Proposal for amendments to ECE/TRANS/WP29/GRRF/2018/10

Proposal for a Supplement to UN Regulation No. 79 (Steering equipment)

The text reproduced below was prepared by the expert from the United Kingdom of Great Britain and Northern Ireland proposing to introduce provisions in UN Regulation No. 79 (Steering equipment) for the approval of Remote Control Manoeuvring (RCM) systems. The modifications to the existing text of the Regulation are marked in tracked changes. The modifications to the original proposal are noted as follow:

M1 N1 category

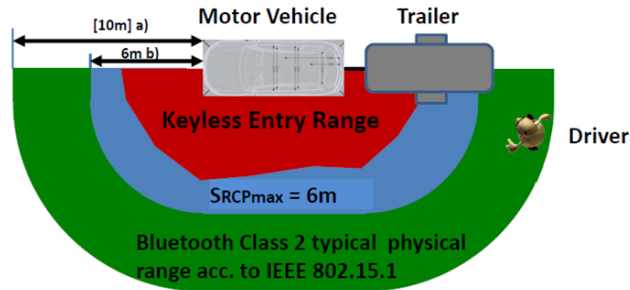
- It is proposed to increase the maximum distance from 6m for RCP, up to 10m for RCM on M1 M2 M3 N1, and 15m for N2 N3.
- The purpose is to cover the complete vehicle combination, in order to permit the driver to stand behind the rear of the trailer when using RCM in reverse direction.
- Additionally, there is no technical standard for an antenna in the trailer nor communication to the motor vehicle.
- Below the example of typical M1 N1 vehicle with a trailer (justifying the need for 10 m)

UN-ECE-R79 ongoing change: Topic Cat. A with a trailer hitched SRCP_{max}
 technical background: „Keyless Go/Entry” maximum range (red) is less than 6m (blue);
 The min. range for the driver to monitor the area behind the trailer is more than 6m.

12. Paragraph 5.6.1.3.7: similar to RCP requirements 5.6.1.2.7.
